North Carolina Department of Environment and Natural Resources  
Division of Land Resources  
Land Quality Section

RE: Permit No. 92-10  
Triangle Mine  
Wake County  
Neuse River Basin

November 24, 2010: This permit has been modified to increase the affected acreage at this site to 156.6 acres as indicated on the Site Plan Maps last revised November 22, 2010. The modification includes the construction of a stockpile area contiguous to the existing plant and stockpile yard and includes the installation and maintenance of all associated erosion and sediment control measures.

**Wake Stone Corporation Triangle Quarry  
Mining Permit No. 92-10  
Application for E& SC Plan Modification  
October 27, 2010**

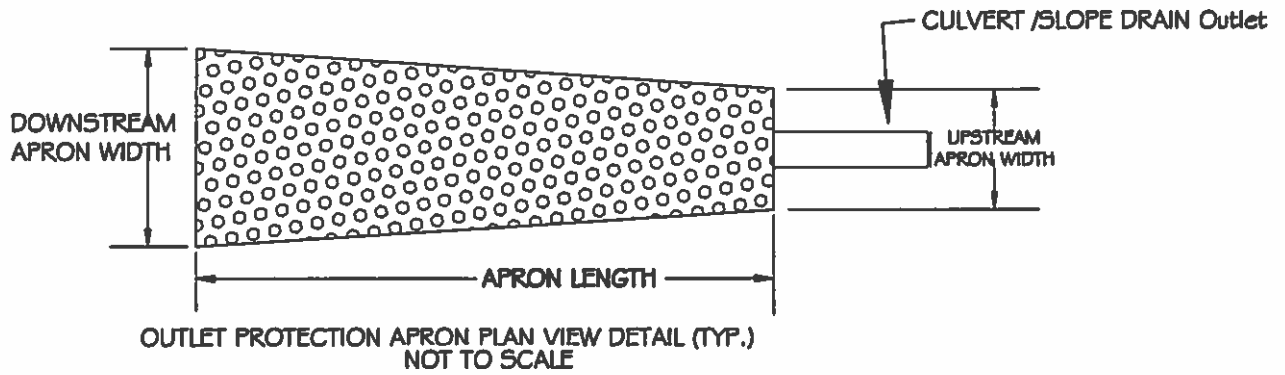
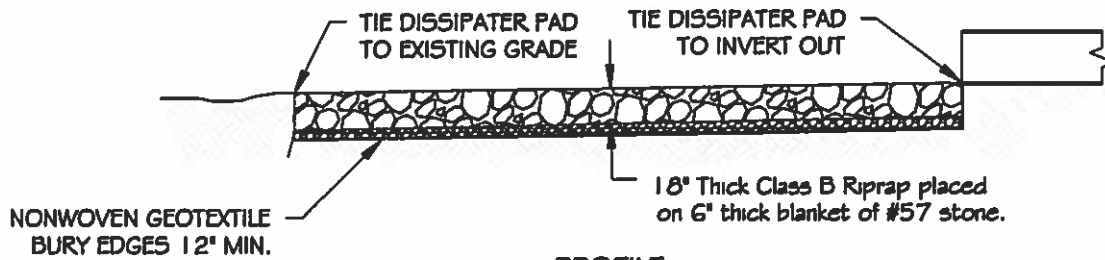
I found a CAD/typo in the revised plan set - Sheet 4 of 4. The attached pdf provides the corrected dimensions for the outlet protection proposed for Basin 2010-1 barrel and the 24" slope drain that will direct runoff from the stockpile area to the fore bay of Basin 2010-1.

Width at pipe outlet	Width at downslope end	Minimum Apron Length
Basin 2010-1 18" CMP Barrel	4.5'	17.0'	12.0'
24" Corrugated Plastic Pipe Slope Drain	6.0'	6.0'	10.0'
